# E350

## U1200, U3300 and U3350

RELEASE NOTES FOR F/W VERSION 6.1

Major and Minor Number

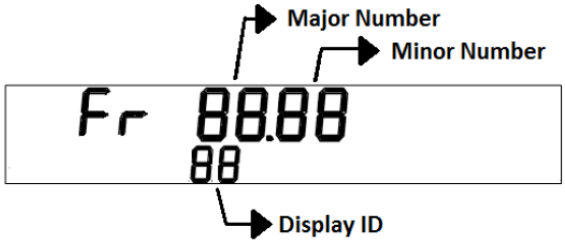
The display list now includes **Firmware Revision** and **Firmware Build Number** as separate display items.
